# PARTS & SERVICE NEWS

REF NO.	AT99219
DATE	Feb. 7, 2000

**SUBJECT:** REPAIR OF ENGINE MOUNTING BOLT ON WA100-3 – WA250-3

### 2. List of parts

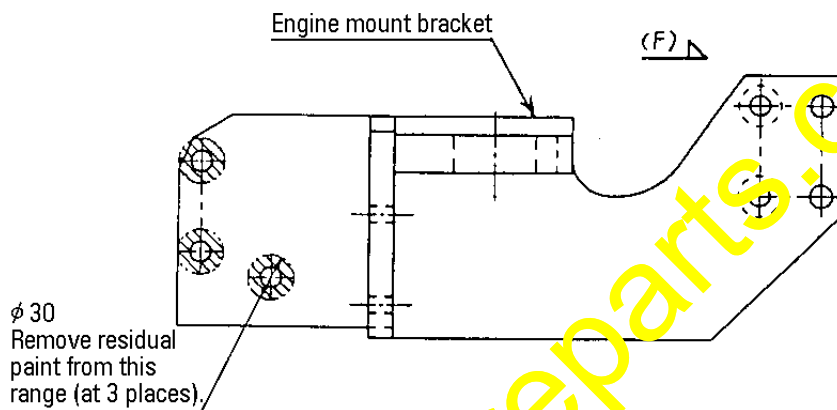
As for the rear side mounting bolts (3 units) for the engine mount bracket on the RH side of the chassis, we have replaced the current washer-faced-head bolts with bolts plus washers to reduce the bearing pressure applied to the bearing surfaces of the mounting bolts to eliminate fatigue thereby to prevent loosening of the mounting bolts.

- 1) Remove the mounting bolts (washer faced head bolts) for the engine mount bracket on the RH side of the chassis.
- 2) Remove the remaining paint from the contact surfaces, to the bearing surfaces of the mounting bolts, on the engine mount bracket. (For the range of  $\phi 30$  at 3 places)

- 3) Install the bolts (01010-81240) plus washers (01643-31232).  
The tightening torque range for the mounting bolts should be 10 – 12.5 kgm.
